SUBJECT: RESPONSE TO THE NOTICE OF DISAPPROVAL FOR THE PUEBLO CANYON AGGREGATE AREA INVESTIGATION WORK PLAN DATED JULY 26, 2005

**Response to the Notice of Disapproval for the
Pueblo Canyon Aggregate Area Investigation Work Plan
Dated July 26, 2005**

**Response to the Notice of Disapproval for the
Pueblo Canyon Aggregate Area Investigation Work Plan
Dated July 26, 2005
Los Alamos National Laboratory EPA ID No: NM0890010515
HWB-LANL-03-007**

Figure 4.12-1. SWMU 00-039 proposed sampling locations and depths

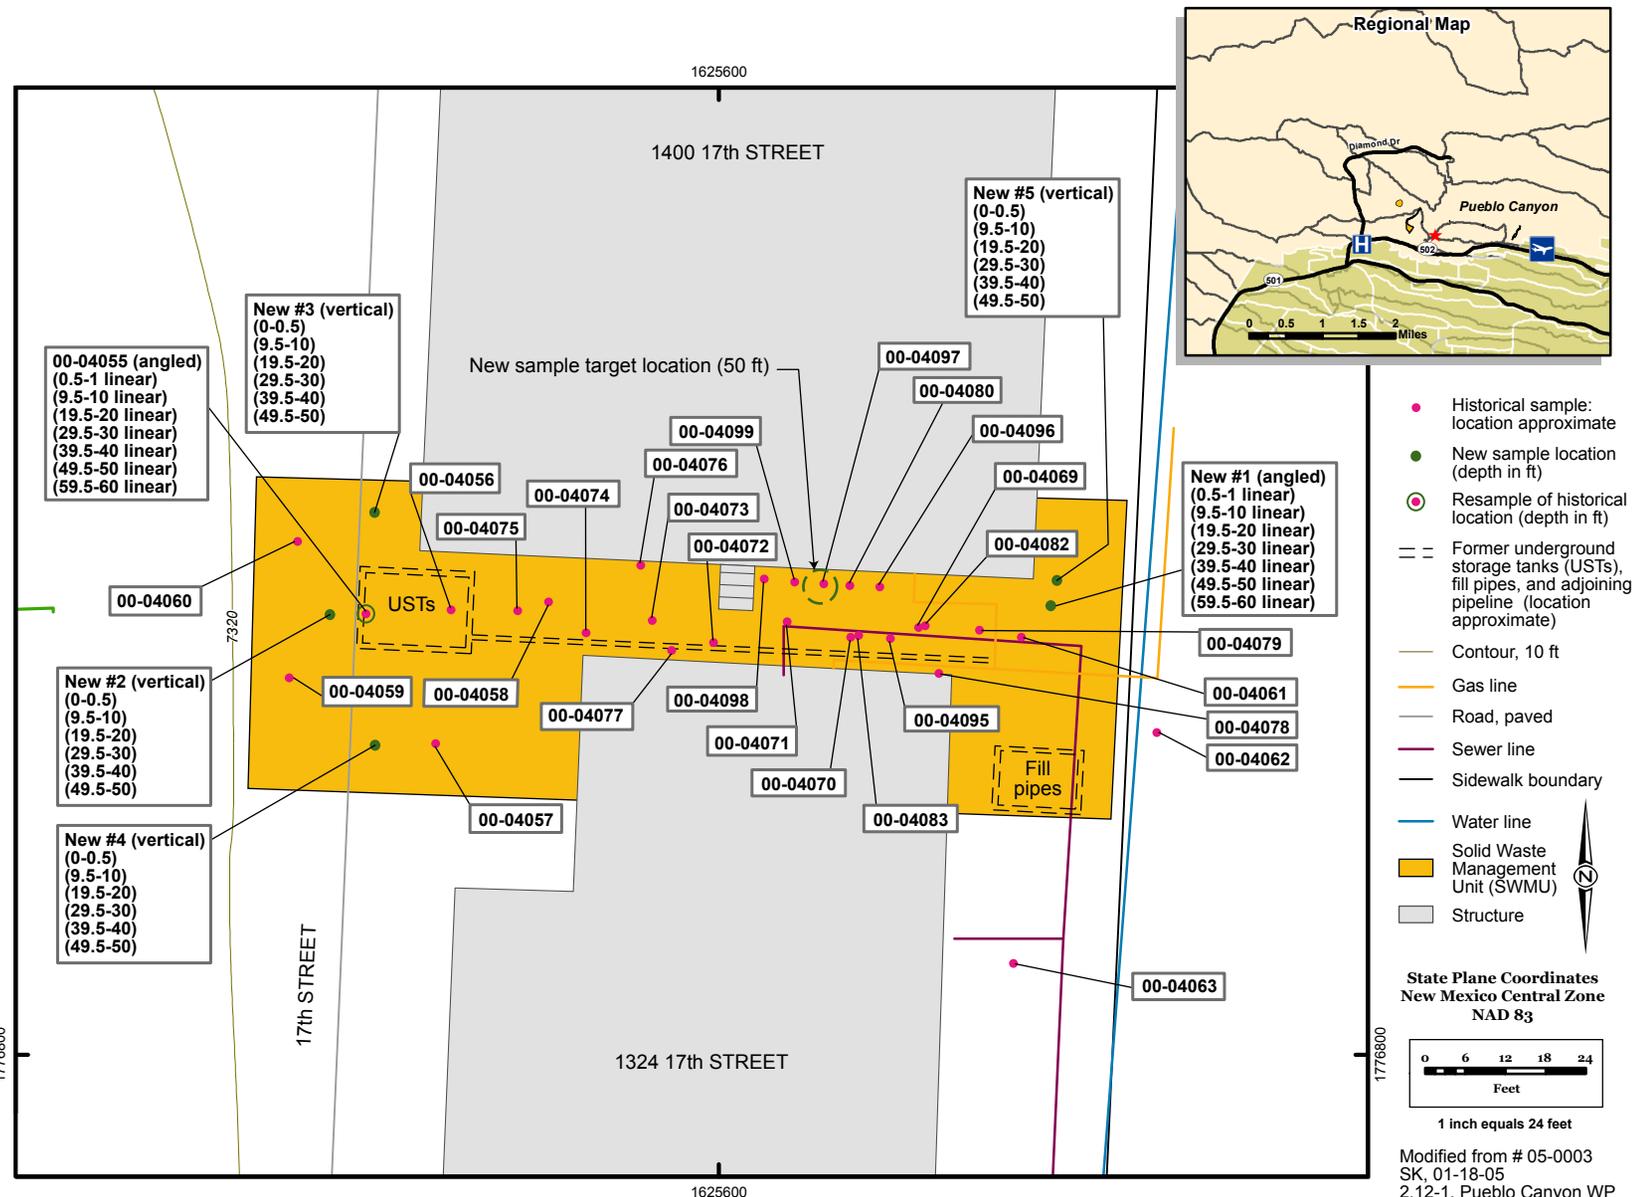
- Section 4.12 Sampling and Analysis for SWMU 00-039, Underground Tanks, pg. 90:

The Permittees have identified additional data needs based on historical data that were obtained from a mobile chemical lab during a 1995 investigation. The samples were only analyzed for TPH and VOCs. Given the uncertainty associated with historical mobile chemical laboratory data and NMED's position that mobile laboratory data cannot be used to determine the extent of contamination at a site (or for confirmatory samples following remediation), the Permittees must propose additional investigation of this site. The investigation must include analysis of VOCs, SVOCs, TAL metals, and TPH.

- During federal ownership of the property at SWMU 00-039 (1945–1968), the site was used for dry-cleaning businesses, and the only potential chemicals of concern related to these operations are organic compounds (VOCs, SVOCs, and total petroleum hydrocarbons [TPH]). LANL proposes the following sample locations and depths to investigate the nature and extent of organic chemical contamination at SWMU 00-039.

- An angled borehole at historical location 00-04055: The borehole will be advanced eastward towards the central portion of the tetrachloroethene (PCE) plume with a target depth of 50 ft bgs. This target depth corresponds to approximately 25 ft beyond the deepest detected contamination within the PCE plume, as determined in the 1995 RCRA facility investigation (RFI). Samples will be collected at 10-ft intervals and analyzed for VOCs, SVOCs, and TPH.

- A vertical borehole at historical location 00-04055 (paired with the angled borehole at location 00-04055) to be advanced to 50 ft bgs: Samples will be collected at 10-ft intervals and analyzed for VOCs, SVOCs, and TPH.

- Two additional vertical boreholes in the western portion of the SWMU and one in the eastern portion of the SWMU: The boreholes will be located to define the depth of potential organic contamination along the perimeter of SWMU 00-039. Samples will be collected at 10-ft intervals to a total depth of 50 ft bgs and analyzed for VOCs, SVOCs, and TPH.

The revised text (p. 92), Table 4.12-1, and Figure 4.12-1 are provided in Attachment 2.

Figure 4.14-1. SWMU 31-001 proposed sampling locations and depths

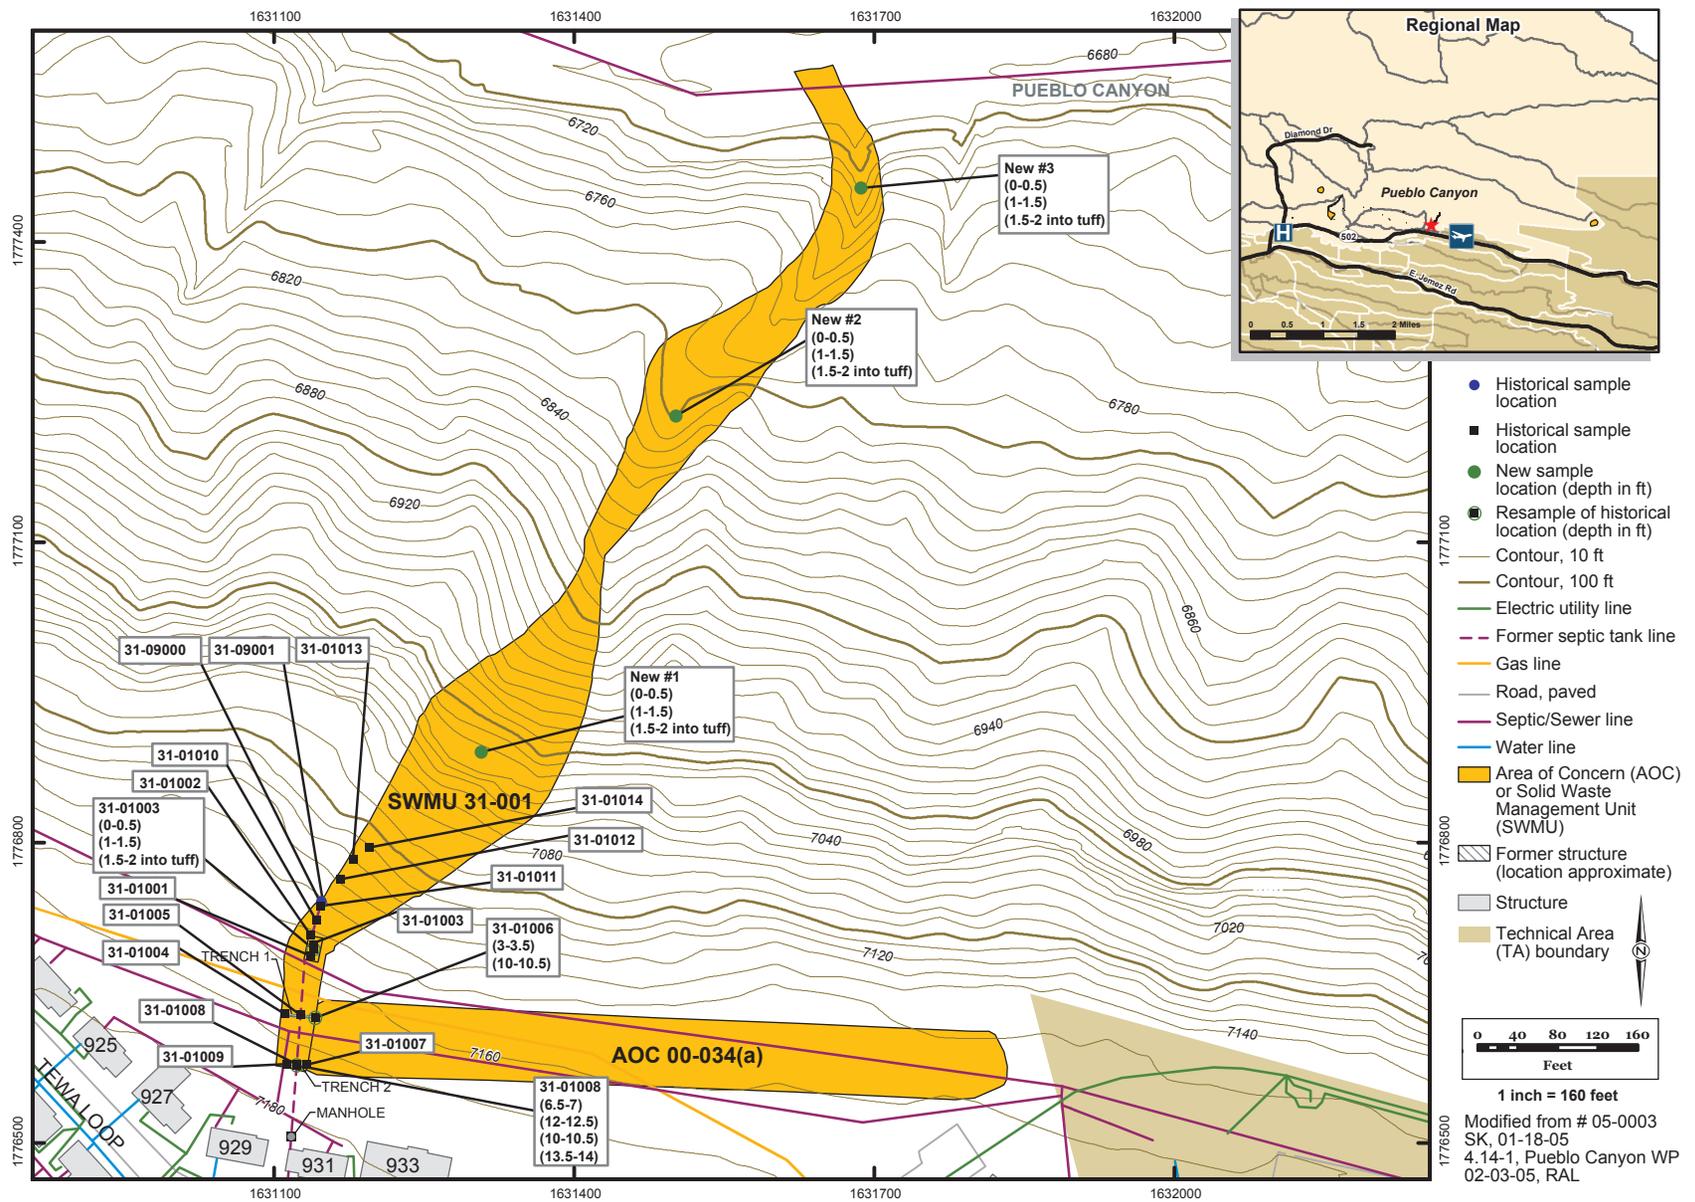
The depth of the former tank is unknown at this location. The Permittees propose collecting samples at three identified depths at this location but do not provide the rationale for these depths. The Permittees must provide this information. Also, see general comment #2.

13. *Figure 4.14-1. SWMU 31-001 proposed sampling location and depths, pg. 225:*

Based on the figure provided, it is not clear the proposed sampling will occur in the drainage. The Permittees must ensure that the samples are collected from sediment accumulation areas or other areas where contaminants are more likely to be present.

11. SWMU 31-001 consisted of a septic tank located aboveground on a bench to the north of the mesa top. LANL proposes sampling beneath the former tank position at historical location 00-01003 at three depths: 0–0.5 ft bgs (soil), 1–1.5 ft bgs (soil), and 1.5–2 ft into the tuff. The sample depths correspond to the aboveground configuration of the tank (the work plan proposed sampling depths based on a belowground configuration). Also, please see the response provided for General Comment #2.

The revised text (p. 93), Table 4.14-1, and Figure 4.14-1 are provided in Attachment 2.

The revised Figure 4.14-1 is provided in Attachment 2.

Figure 4.15-1. Consolidated Unit 45-001-00 [excluding Consolidated Unit 01-002(b)-00] proposed sampling locations and depths

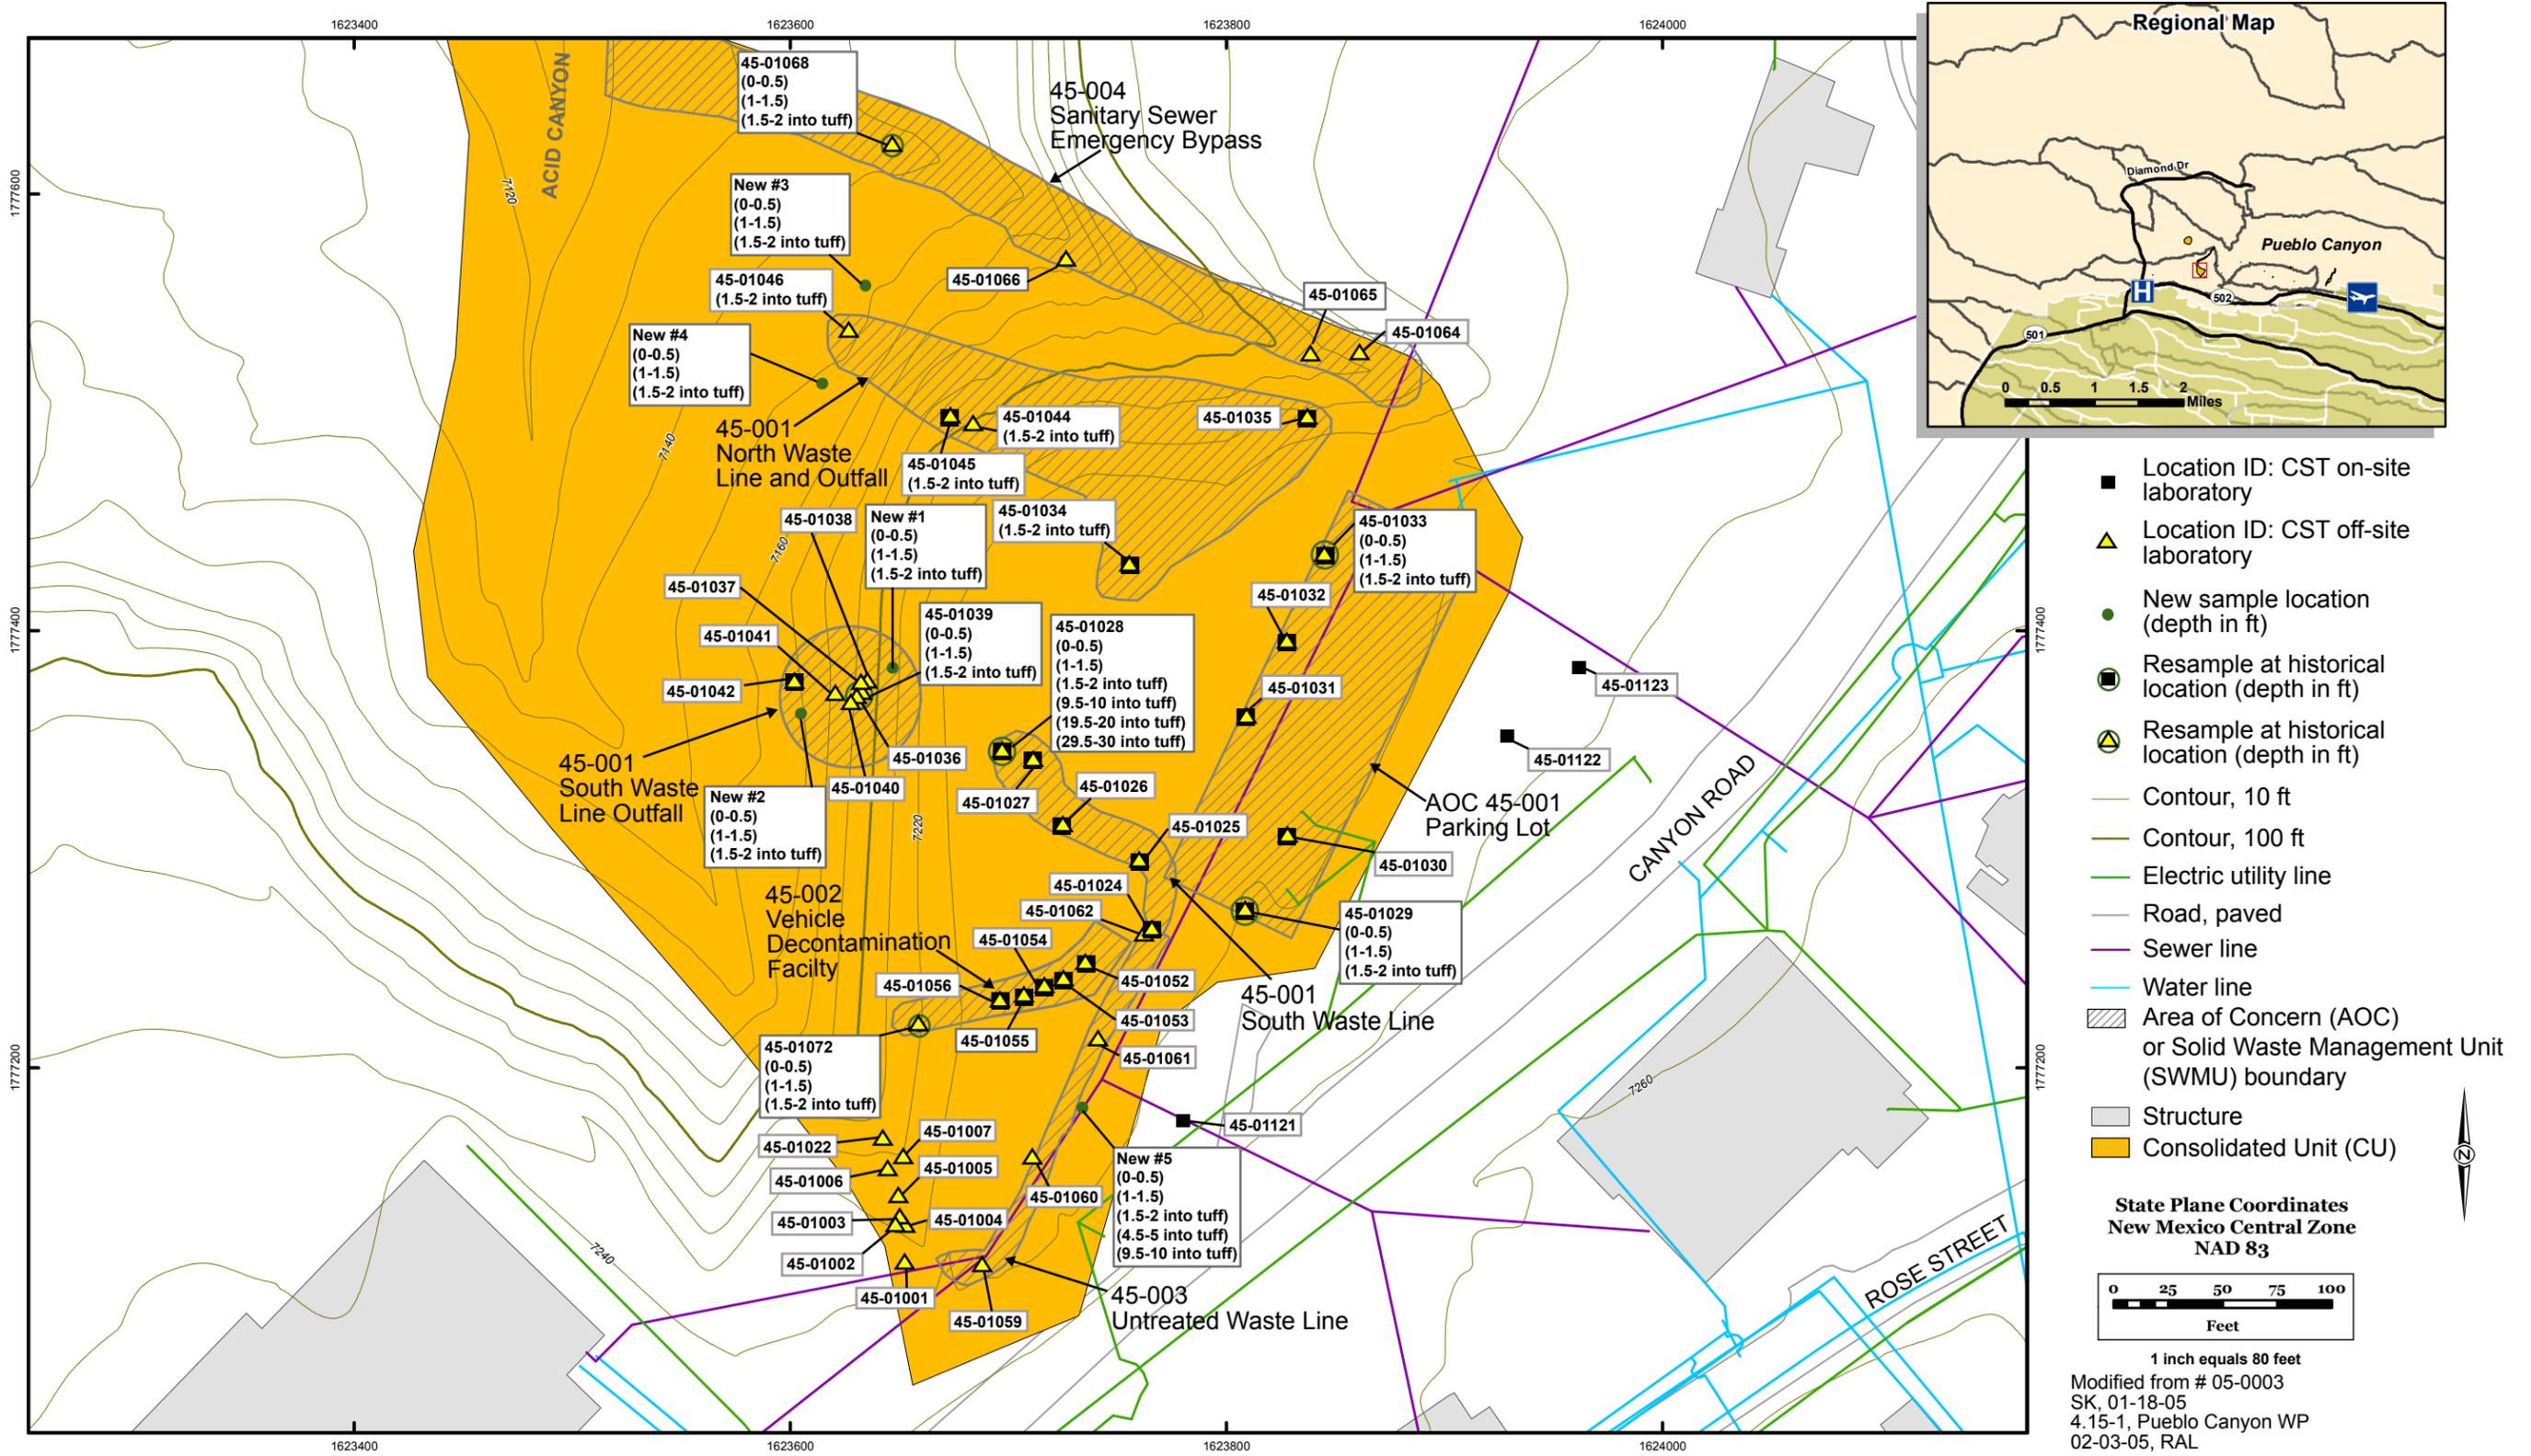
12. Section 4.15 Sampling and Analysis for Consolidated Unit 45-001-00, Wastewater Treatment Plant – TA-45, pgs. 93-94:

- c. *Parking Lot (SWMU 45-001): The Permittees must justify resampling the same depths at location 45-01033. In order to meet the data needs identified by the Permittees, the Permittees should collect samples at deeper intervals at this location. The Permittees are resampling at location 45-01029 but did not provide the previously collected data for this location. The Permittees must provide these data and collect samples at this location at deeper intervals to define extent.*

- e. *Sanitary Sewer Emergency Bypass (SWMU 45-004): The Permittees must provide the data for location 45-01068 and justify resampling at the same depths at this location.*

The revised text (pp. 94–95), Table 4.15-1, and Figure 4.15-1 are provided in Attachment 2.
